To: Snyderville Basin Cemetery District Board Members

From: Dana Jones, *District Director* 
Prepared by Maddie Nelson, *Open Space Supervisor*

Date: March 19, 2025

Re: Proposed Site Relocation for the Snyderville Basin Cemetery District within the RTS Property

Map 1: Sensitive Habitat and Hillside Area Map

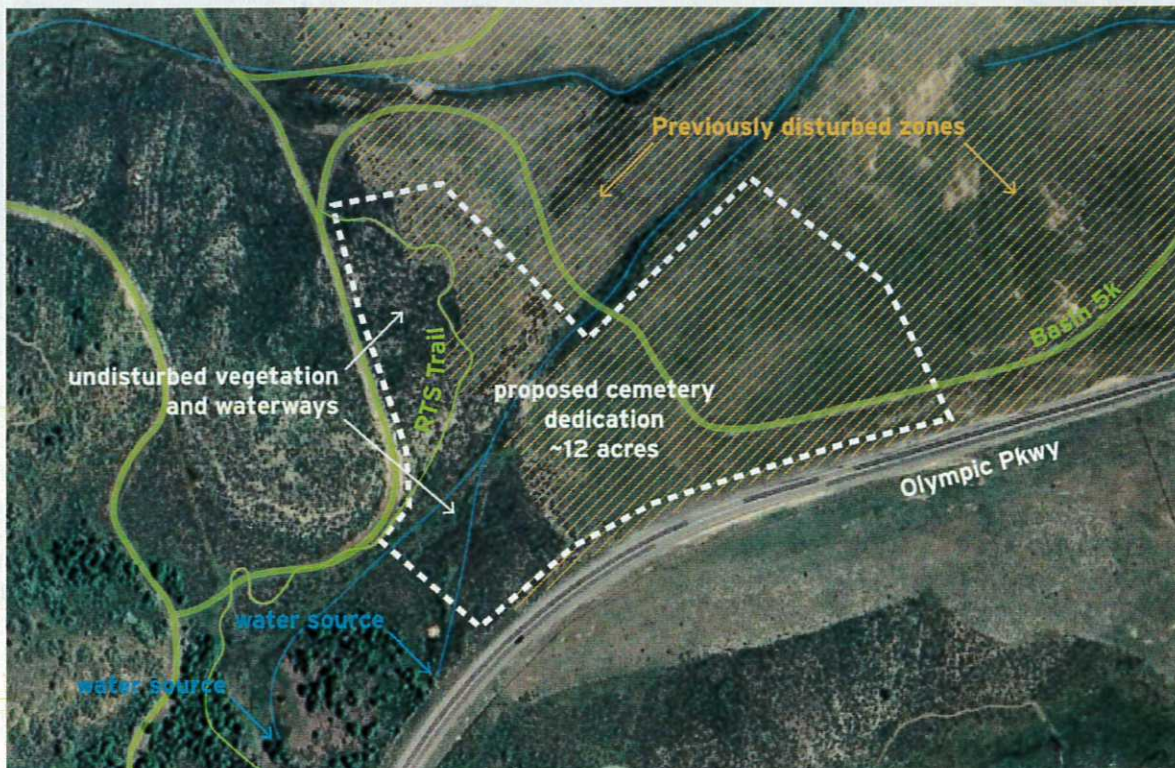
Within the boundaries of the “preferred site” that have been shown to Basin Recreation as of March 12th, 2025 (Map 1, attached), approximately 700 linear feet of existing single-track trail and 750 linear feet of Nordic ski trail would fall within the SBCD boundary. Discussions within Basin Recreation and with other stakeholders in the community about impacts on trail users have led to the conclusion that any existing portions of trail that fall within the boundaries proposed by SBCD would need to be re-routed at a cost to the Cemetery District to avoid conflicting interests between trail users, SBCD staff and visitors.

Basin Recreation officially recommends that SBCD shift their proposed western boundary line approximately 300 feet down the hill towards the east. Basin Recreation is not seeking to reduce the total acreage of the proposed SBCD site, merely to avoid impacting the existing trail system and the sagebrush habitat on the hillside.

The costs of impacting the existing trail system and the habitat far exceed any benefit to SBCD. The hillside does not provide any useable area for internments or infrastructure and is steep and susceptible to erosion, especially if the vegetation is disturbed in any way. Basin Recreation does not endorse the boundaries of the “preferred site” that include any portion of the hillside or drainage area and as a majority owner of the proposed property Basin Recreation requires that SBCD consider an alternative boundary that does not include the hillside or drainage area. Basin Recreation has provided a preferred cemetery dedication boundary (Map 2).
